DESIGN DOCUMENTS NOT FOR CONSTRUCTION
GARDEN SPOT ATHLETICS CAMPUS
FOR
GARDEN SPOT MIDDLE/ HIGH SCHOOL
EASTERN LANCASTER COUNTY SCHOOL DISTRICT
NEW HOLLAND TOWNSHIP LANCASTER COUNTY, PENNSYLVANIA

5/22/26 RFI RESPONSES

GARDEN SPOT ATHLETICS CAMPUS GARDEN SPOT MIDDLE/HIGH SCHOOL Eastern Lancaster County School District

5/22/26 RFI RESPONSES

1 FLOOR PLAN - FIRST FLOOR
1/4" = 1'-0"

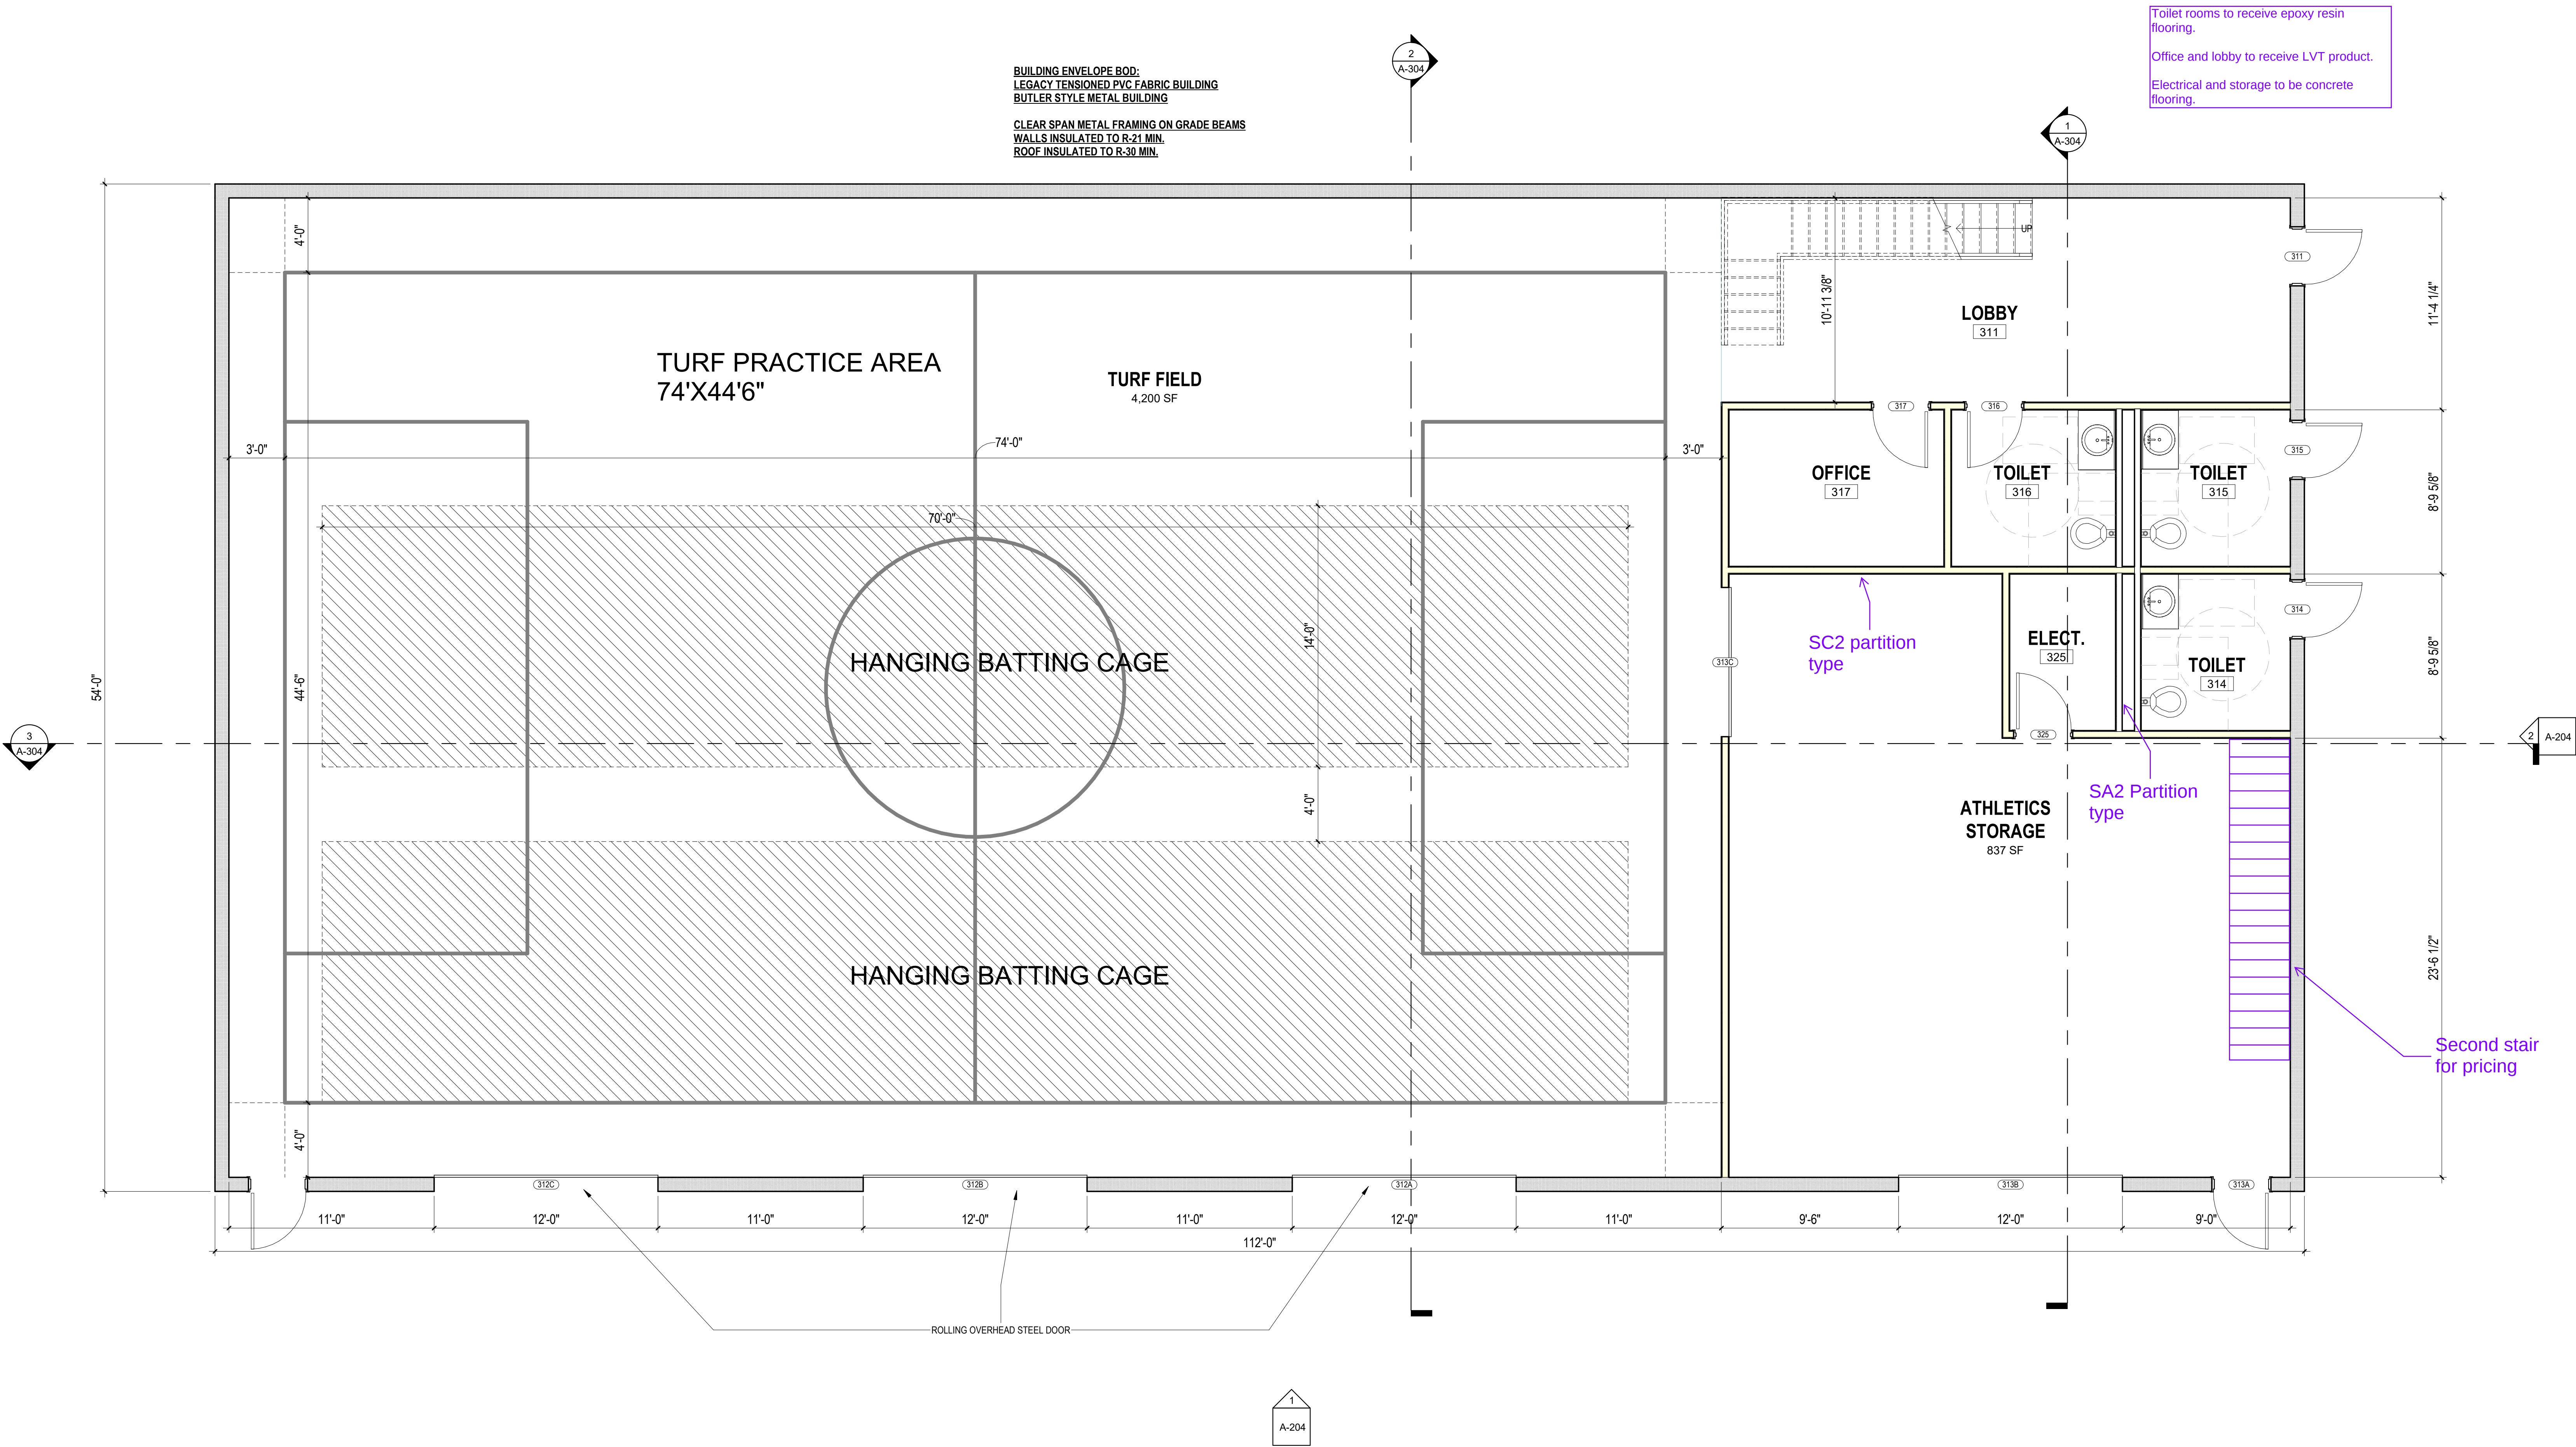
Floors in the following spaces shall be an epoxy resin floor:

- Concessions 101
- Restroom 102
- Womens 103
- Mens 104
- Trainer Annex 105

3 Section 12
1/4" = 1'-0"

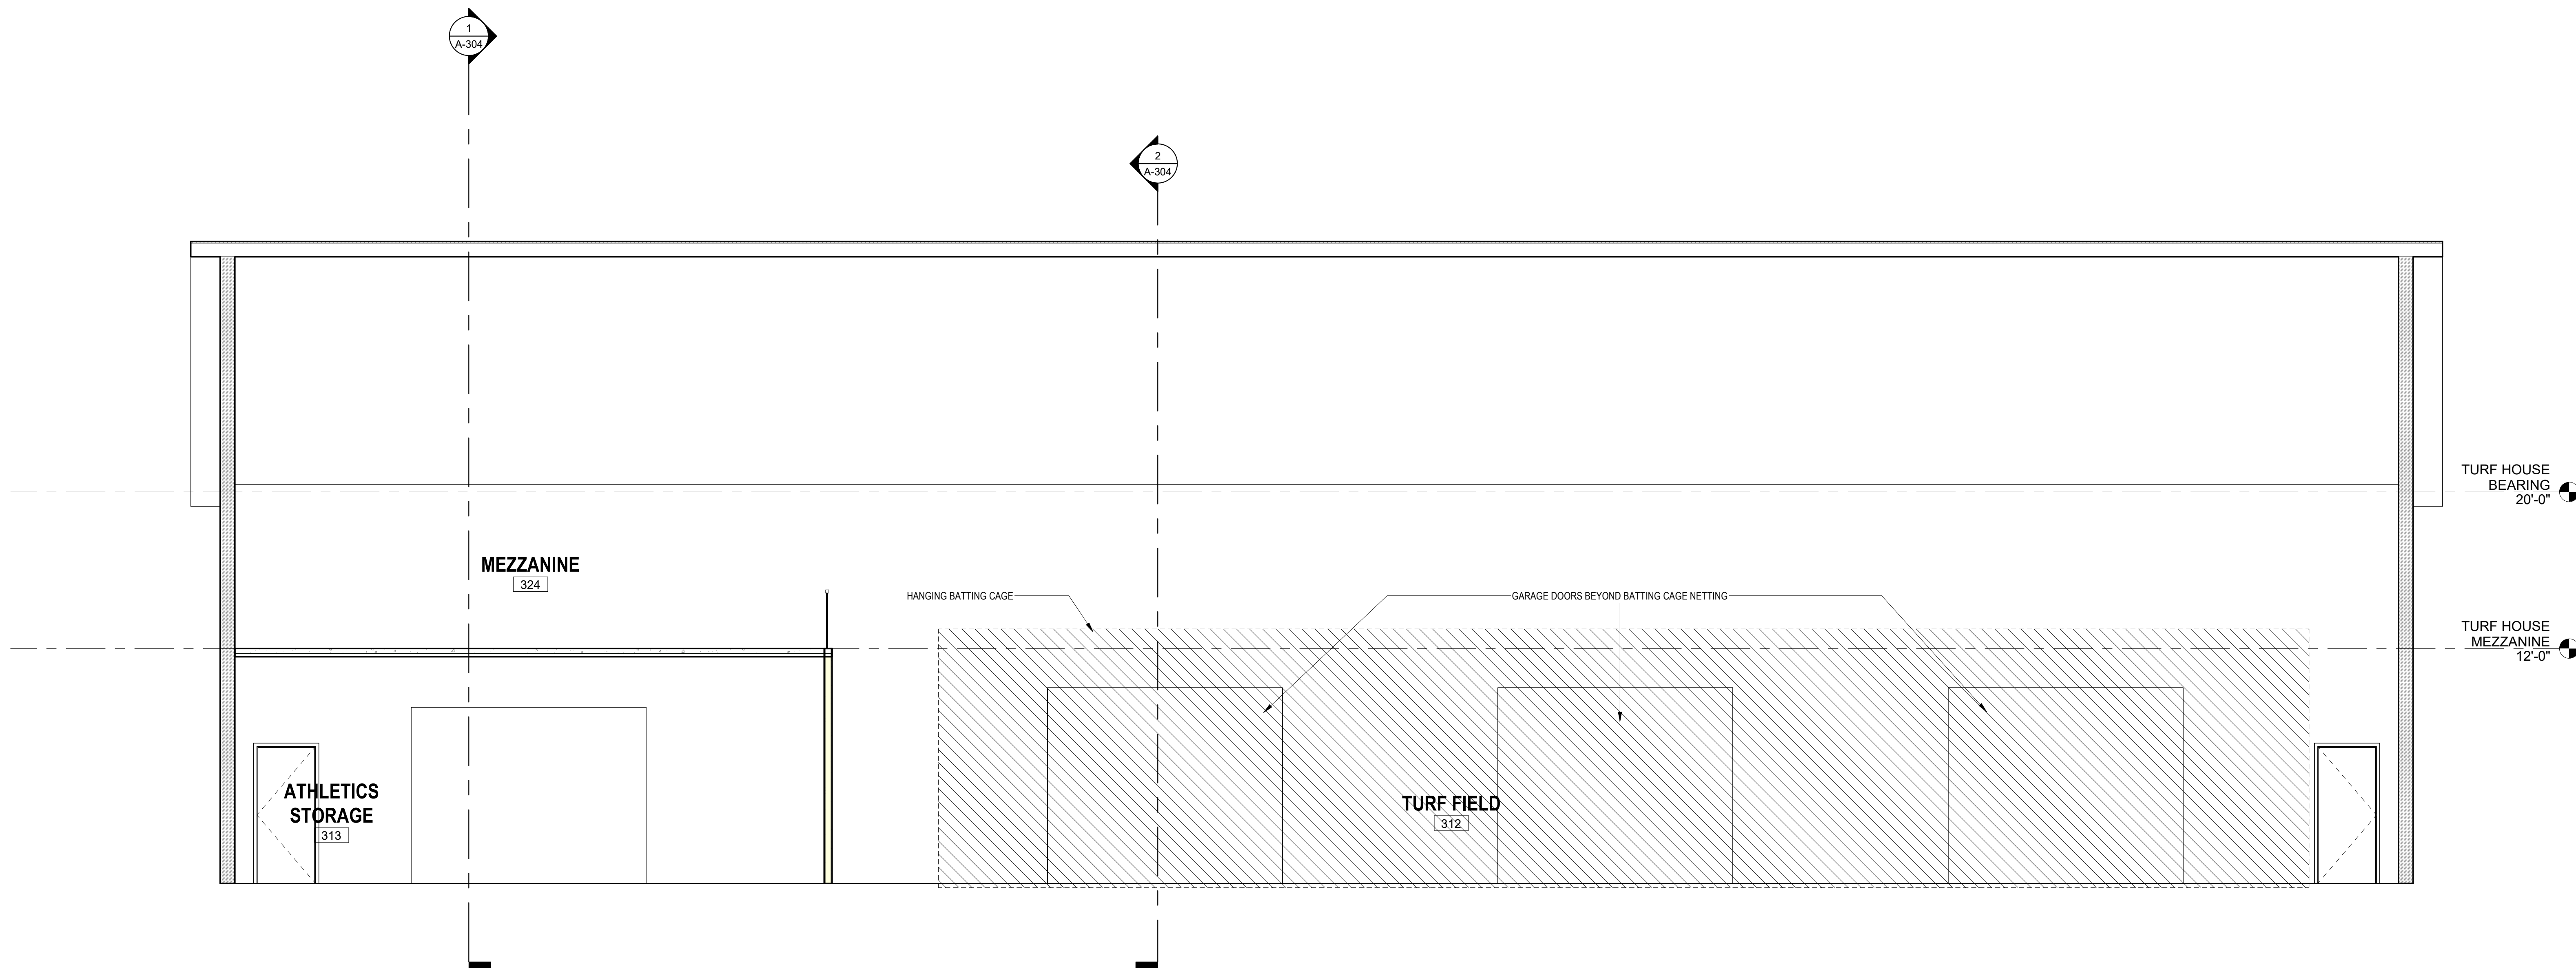
Verify with building manufacturer if structure can be attached to their shell framing

Mezzanine to be metal structural framing and concrete on metal decking for the floor.
